**MADERA UNIFIED  
SCHOOL DISTRICT**  
1902 Howard Road  
Madera CA 93637  
(559) 675-4500  
(559) 675-1186 Fax  
[www.madera.k12.ca.us](http://www.madera.k12.ca.us)

Addendum No. 1-Bid Section 1-5  
Asphalt Resurface & Repairs at Various School Sites  
BID No. 033116

This Addendum is attached to and made a part of the above entitled specifications for Madera Unified School District for BID No. 033116 with a due date of May 5, 2016

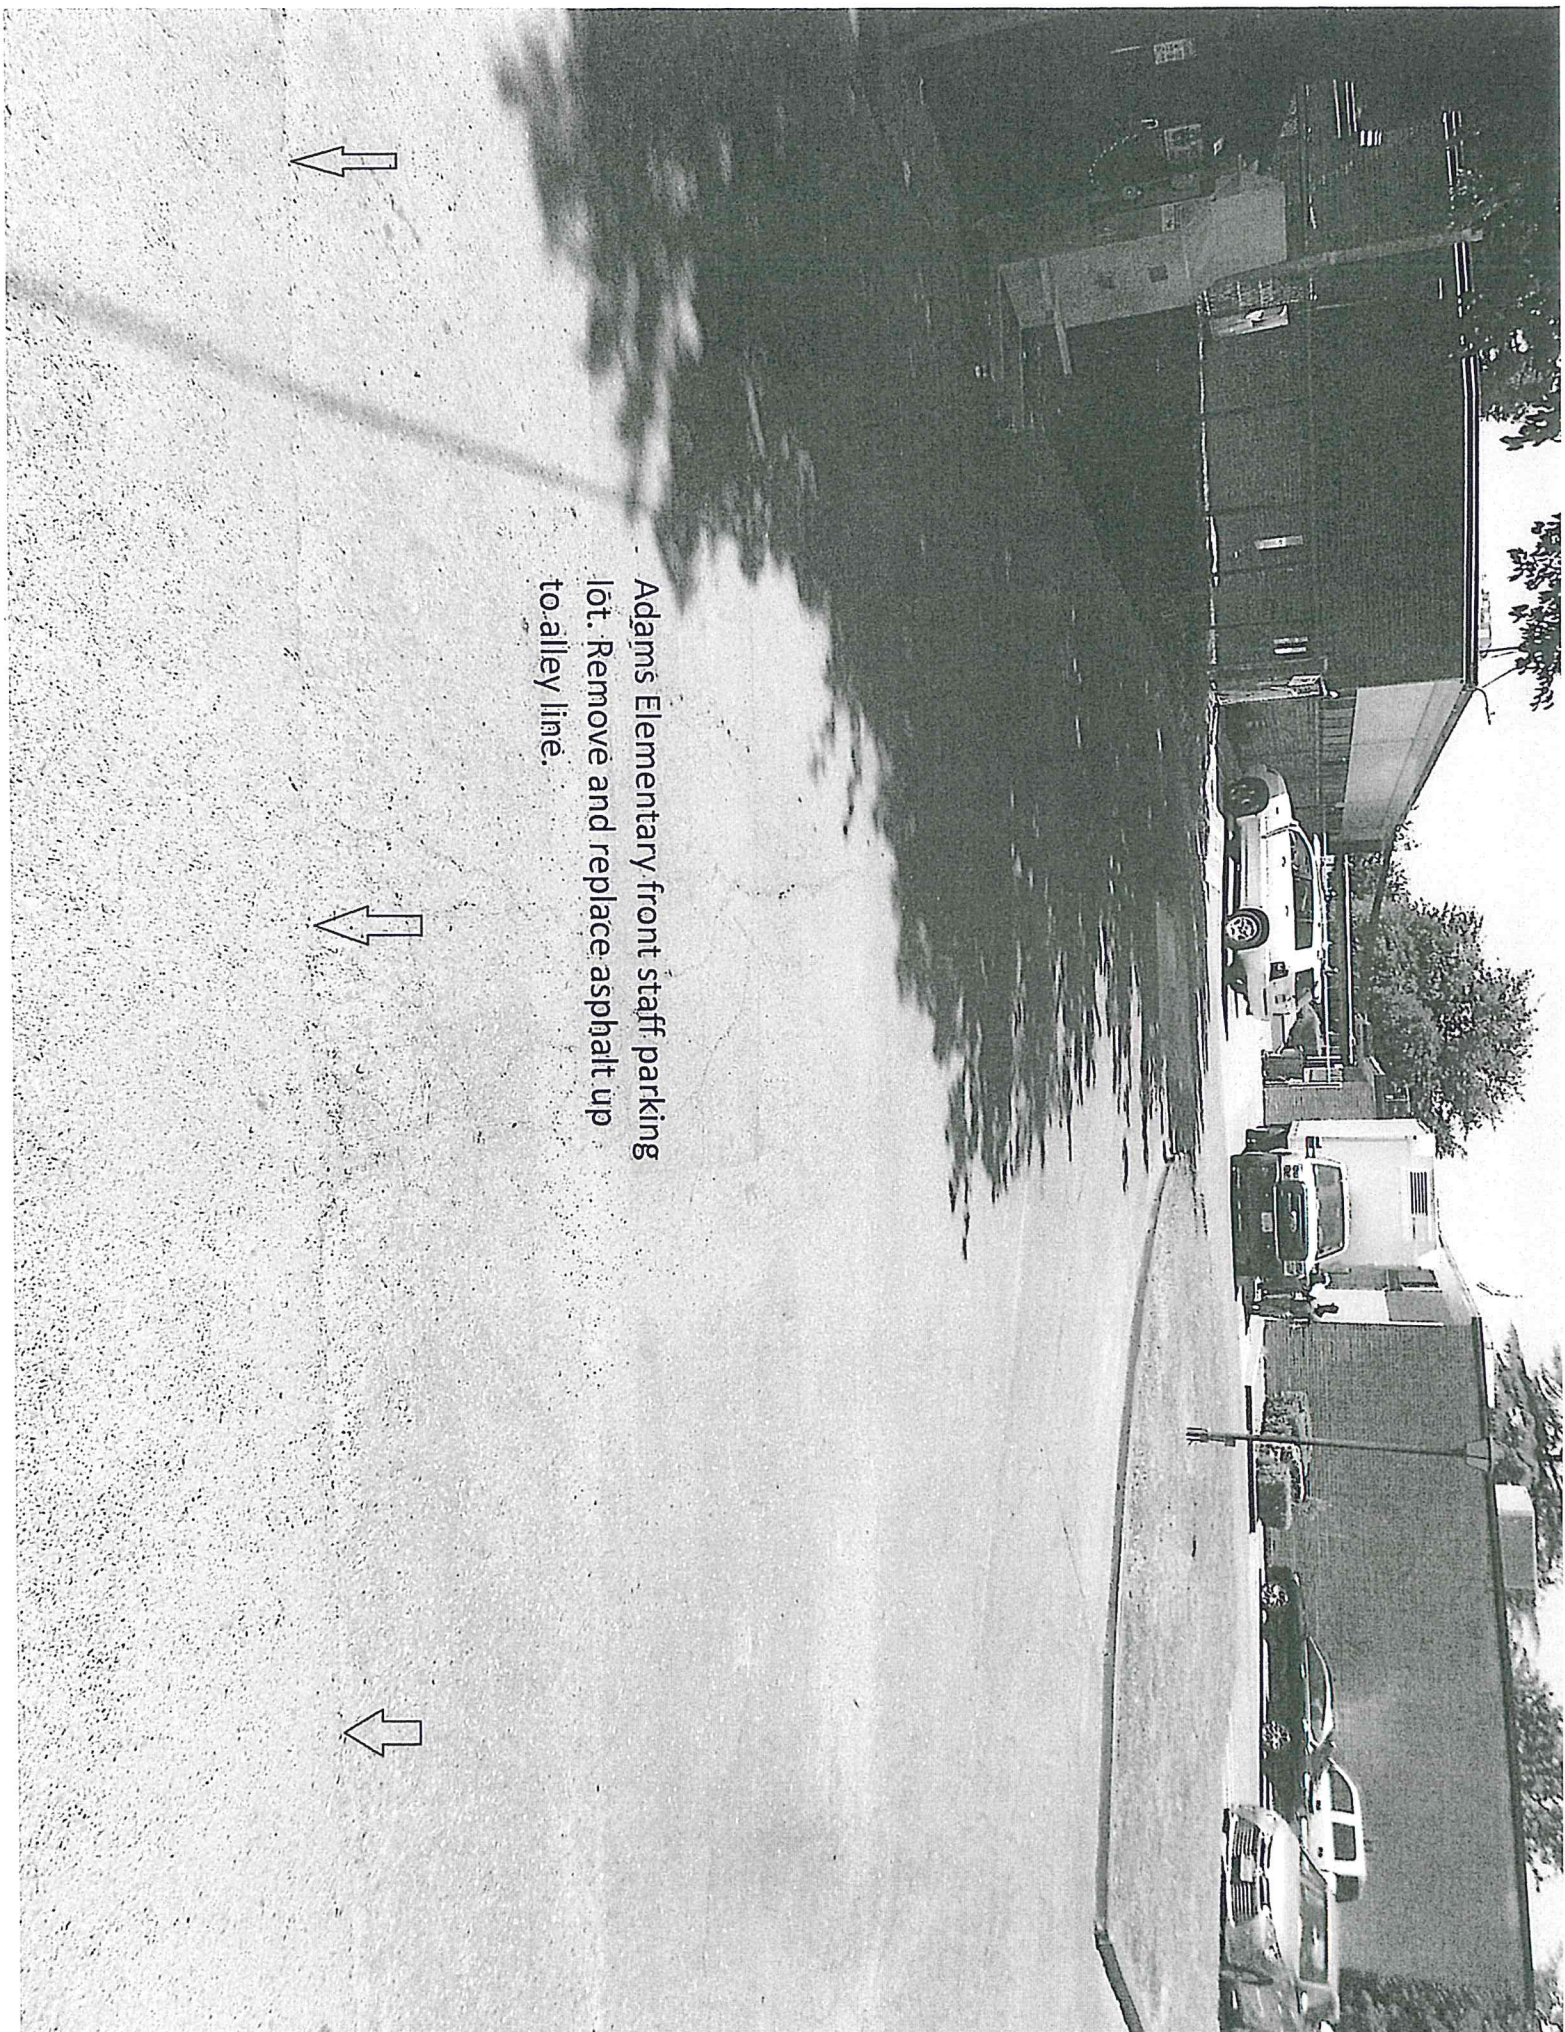
Adams Elementary front staff parking lot. Remove and replace asphalt up to alley line.

Adams Elementary front staff parking lot.  
Remove and replace asphalt. Seal and re-stripe  
parking stalls (typ. both sides of the lot).

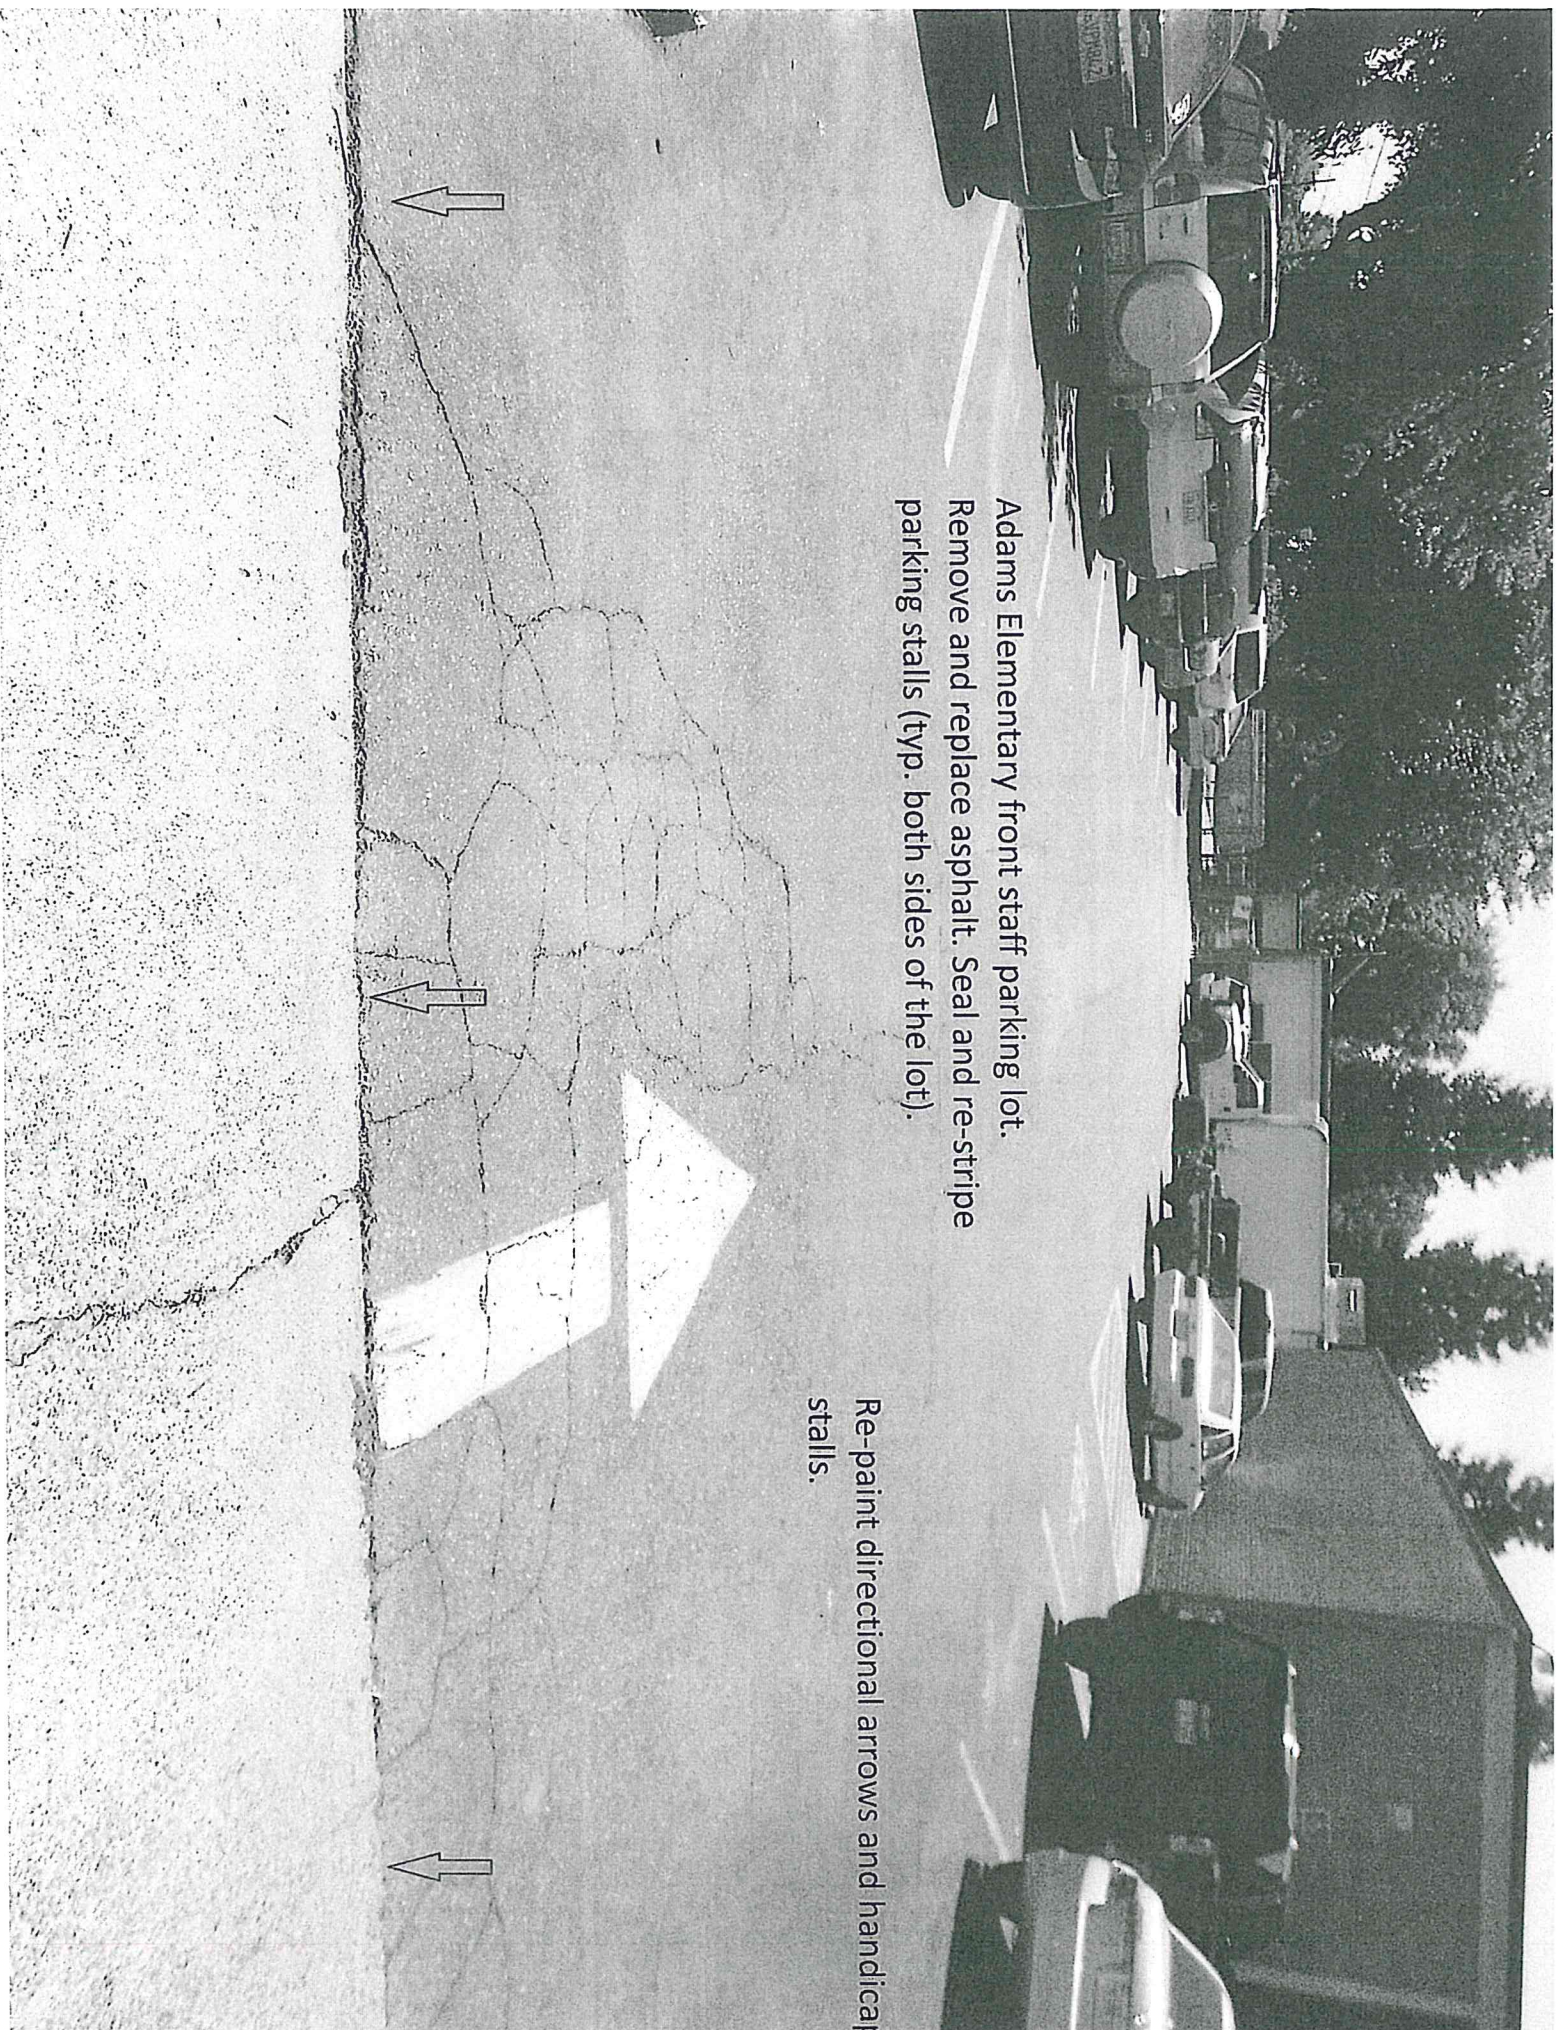
Re-paint directional arrows and handicap  
stalls.

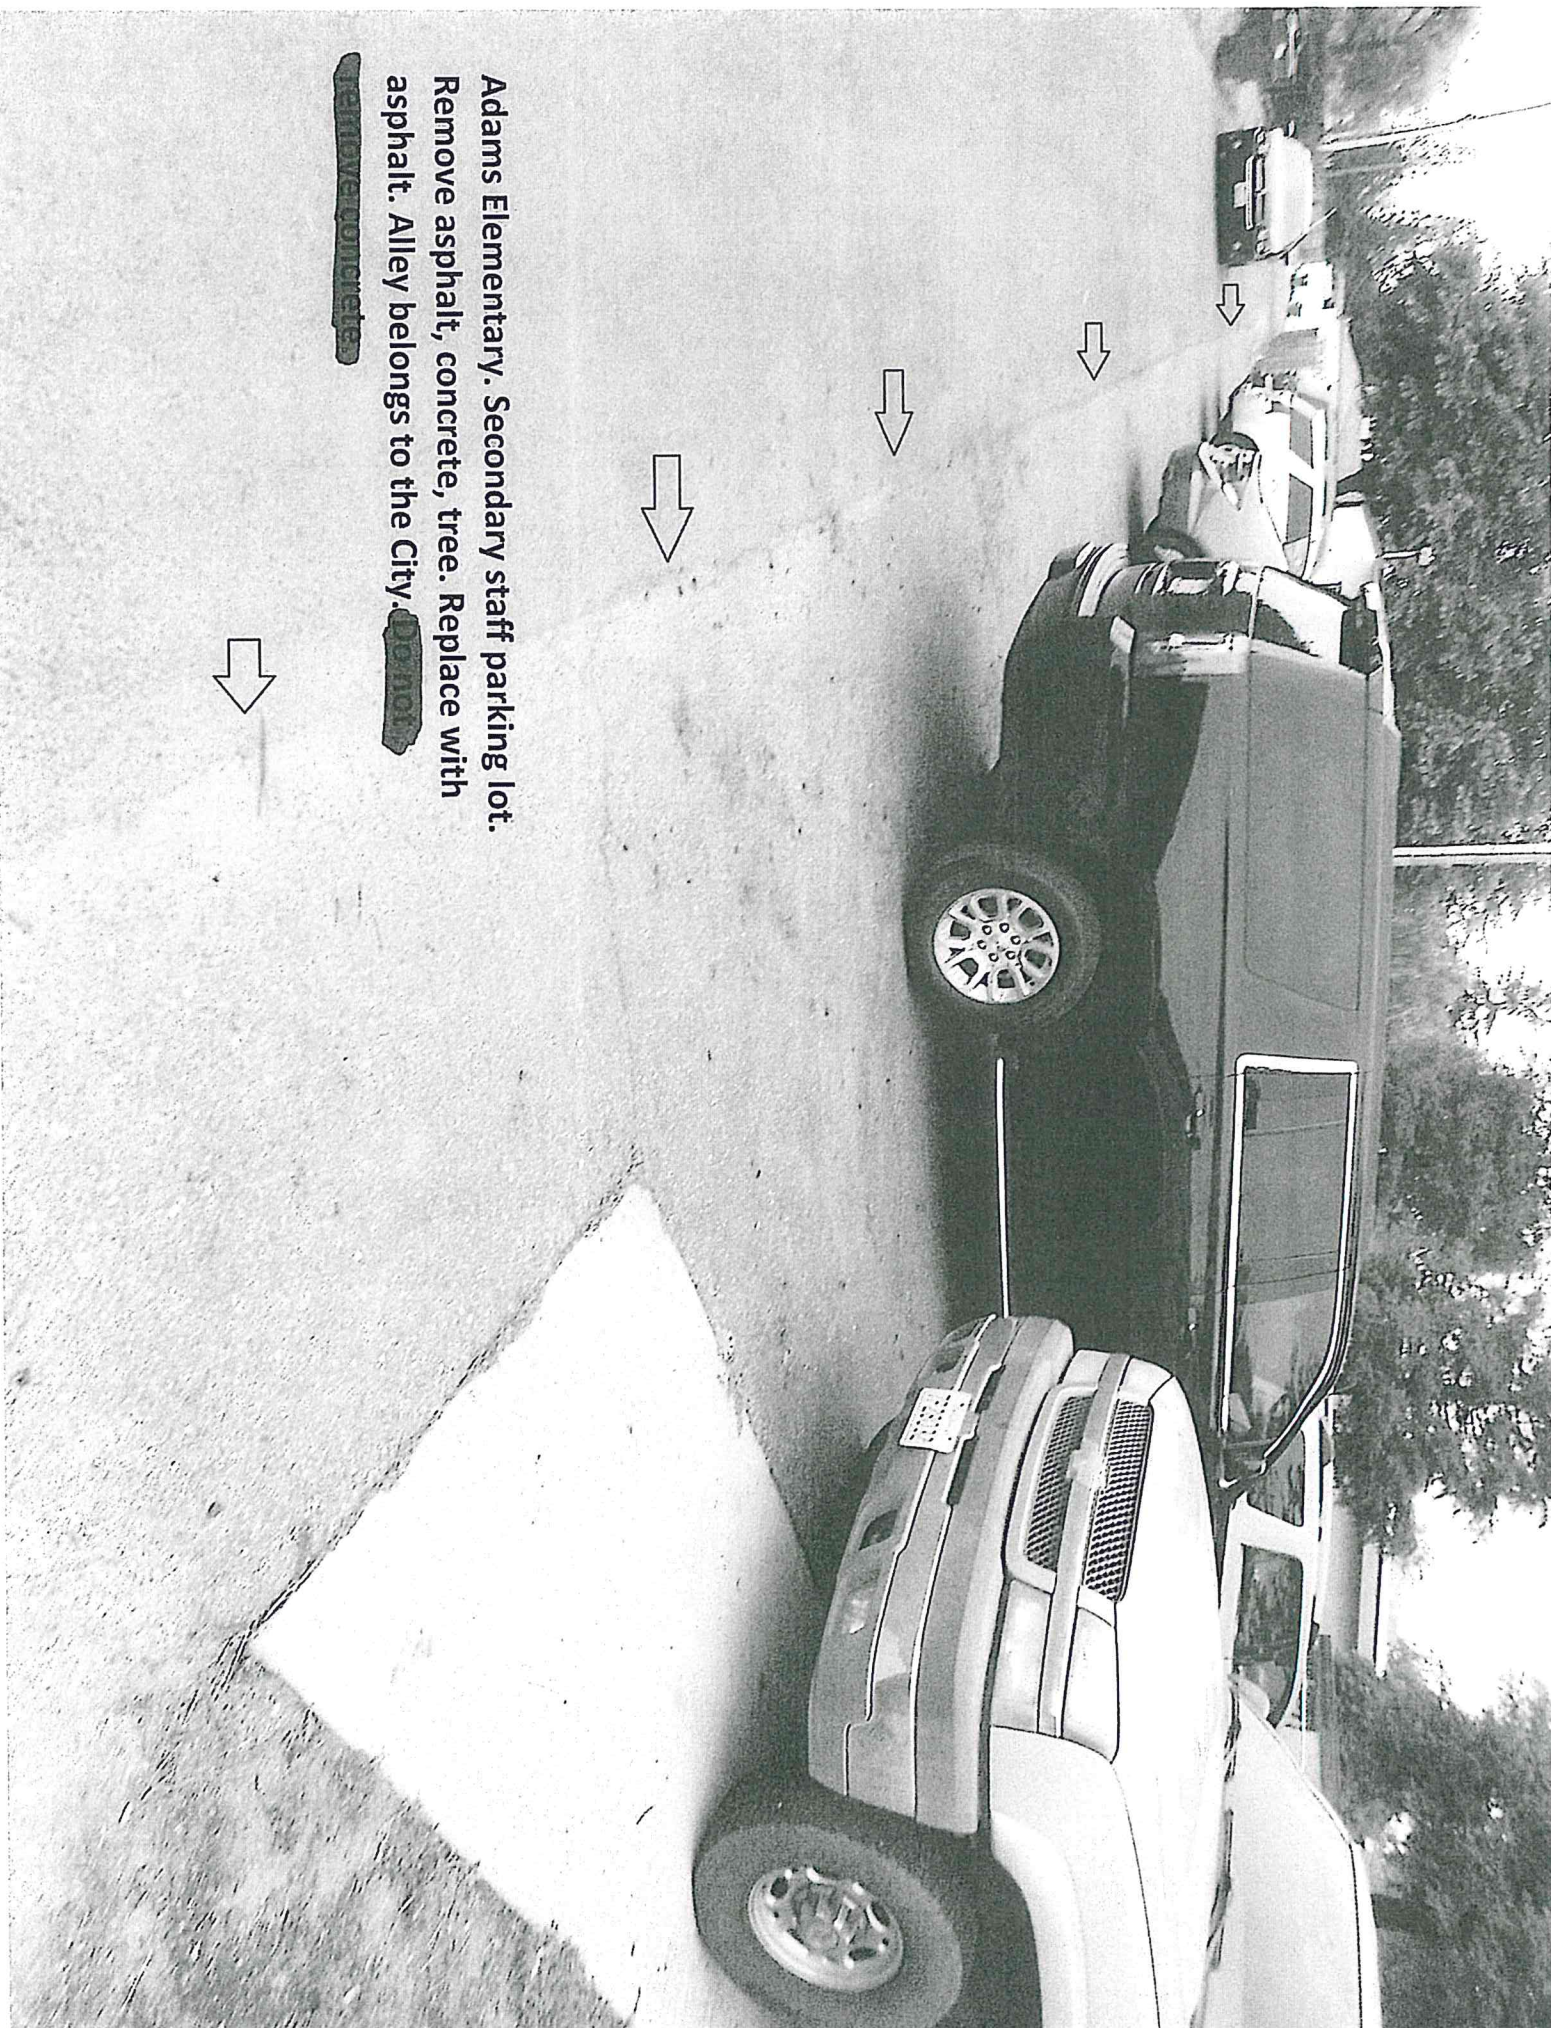
Remove and replace concrete with asphalt in front staff parking lot.

Adams Elementary. Secondary staff parking lot.  
Remove asphalt, concrete, tree. Replace with  
asphalt. Alley belongs to the City.

Remove asphalt, concrete, tree. Replace with asphalt. Alley belongs to the City.
